CITY OF ALBUQUERQUE

RE: **Lot 8 Block 4 Unit 2 SAD 227**
8005 Marigold Rd. NW
Grading and Drainage Plan
Engineers Stamp Date 10/13/2021 (E10D103)
Pad Certification Date 7/30/2021

DRAINAGE AND TRANSPORTATION INFORMATION SHEET (REV 6/2018)

ENGINEER'S SEAL	8005 MARIGOLD	DRAWN BY WCUJ
		DATE 3-24-21
7/30/21	GRADING AND DRAINAGE PLAN	210210032-LAYOUT-3-24-21
DAVID SOULE P.E. #14522	 <i>Rio Grande Engineering</i> 1606 CENTRAL AVENUE SE SUITE 201 ALBUQUERQUE, NM 87106 (505) 872-0999	SHEET # —
		JOB # 21021032

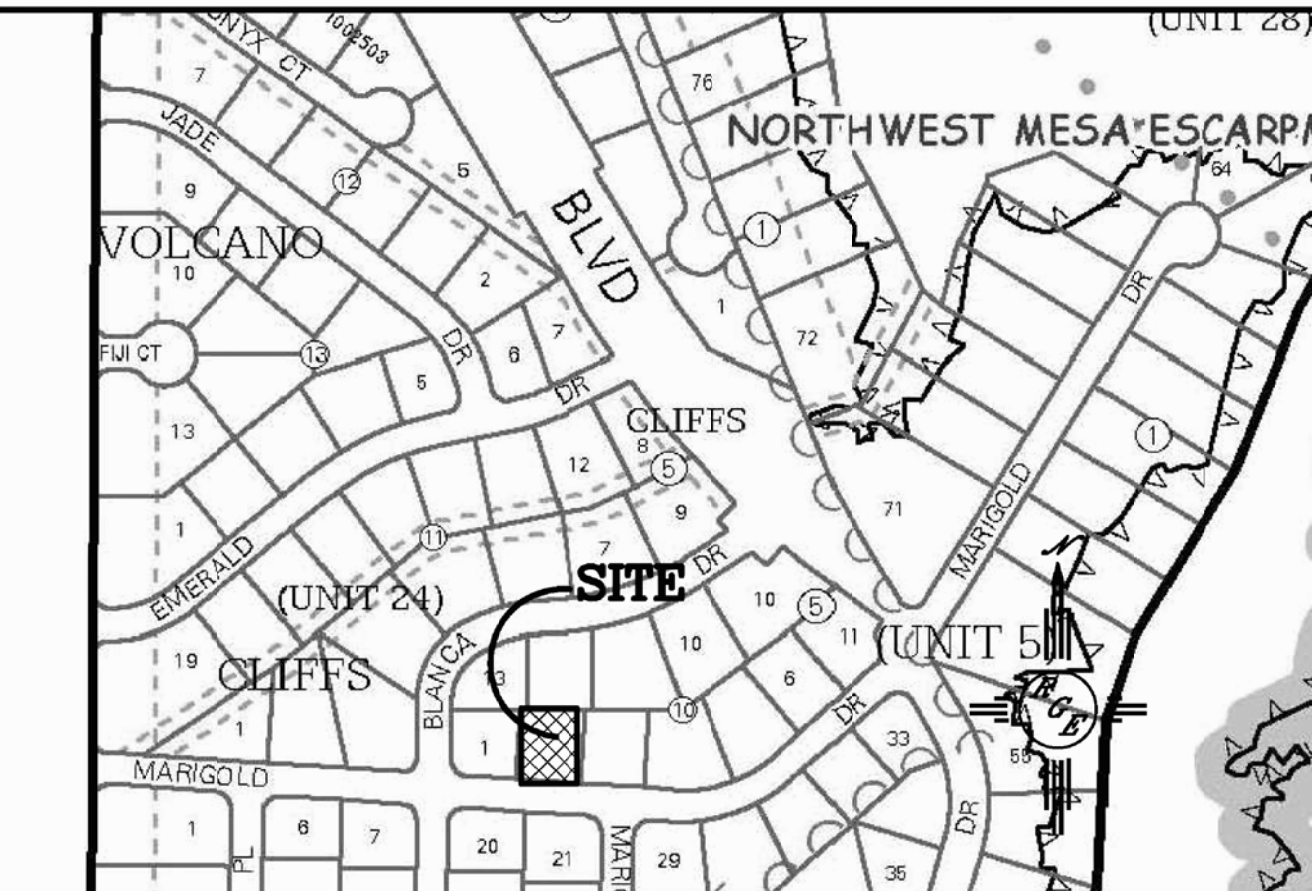
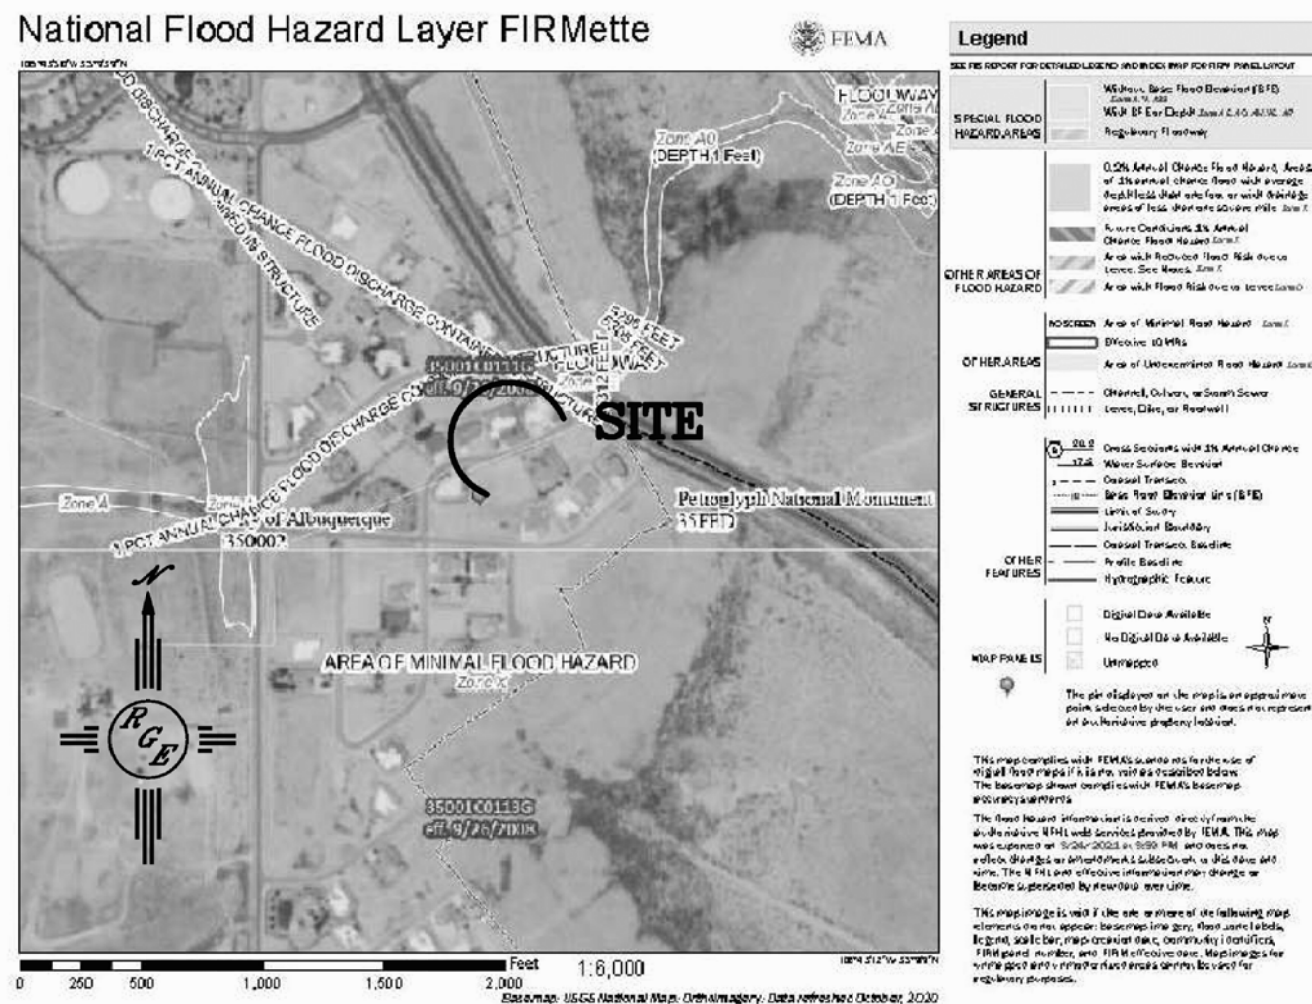
Based upon the information provided in your submittal received 10/13/2021, this plan is approved for Building Permit and SO-19.

Reiterate to the Owner/Contractor that a separate permit for a garden/retaining wall must be obtained, with the approved G&D plan. Also, advise the owner/contractor not to use dirt as a ramp to climb the curb. If dirt is used it will cause a delay in permitting.

Prior to Certificate of Occupancy release, Engineer Certification per the DPM checklist of this plan will be required.
